ASSESSMENT REPORT

Section 96(1A) Modification Erskine Park Waste and Resource Management Facility (SSD 7075 MOD 1)

Figure 4: Proposed Stage 1 DA

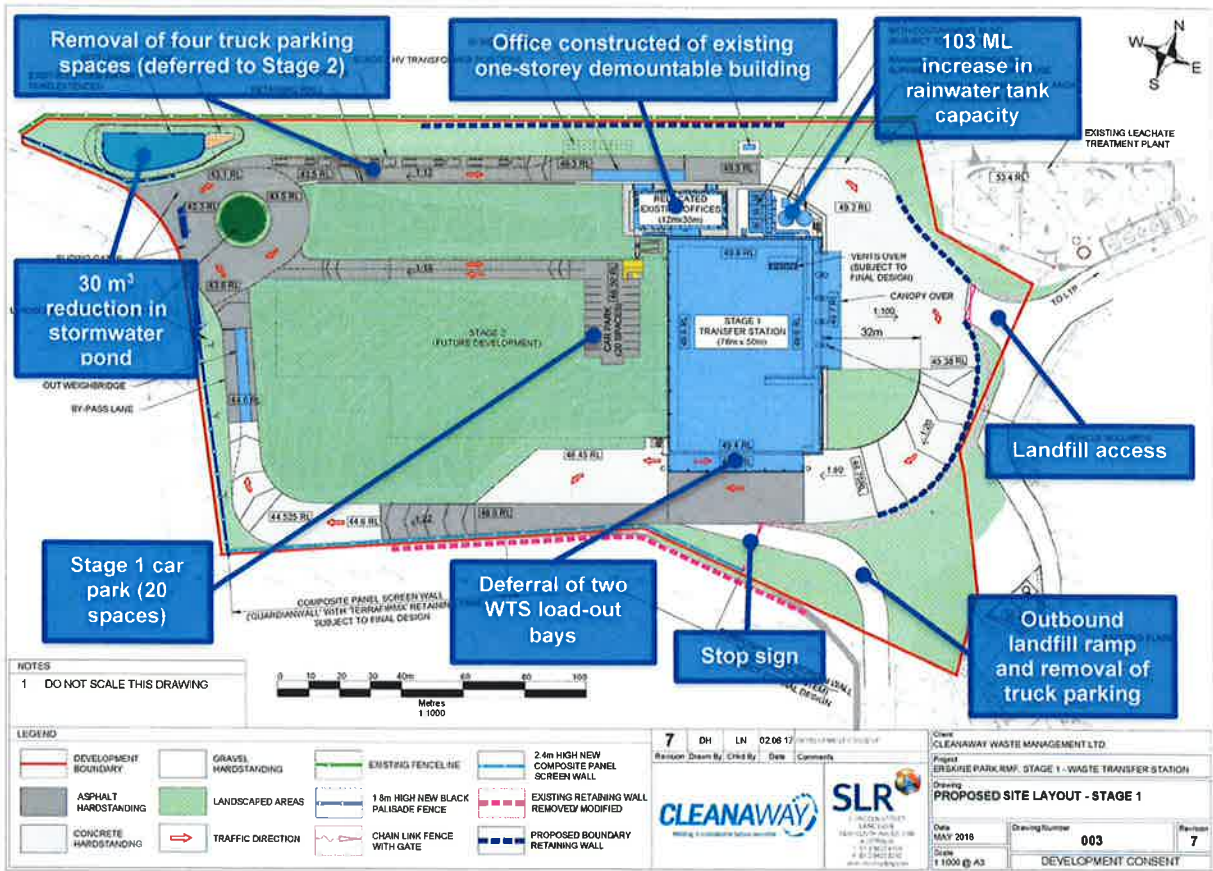
The modification is described in full in the Statement of Environmental Effects (SEE) included in **Appendix B**, is summarised in **Table 1** and is illustrated on **Figure 4** and **Figure 5**. It is noted that whilst the Applicant is seeking to modify the concept proposal, physical works are only permitted under Stage 1. Stage 2 is subject to a future DA.
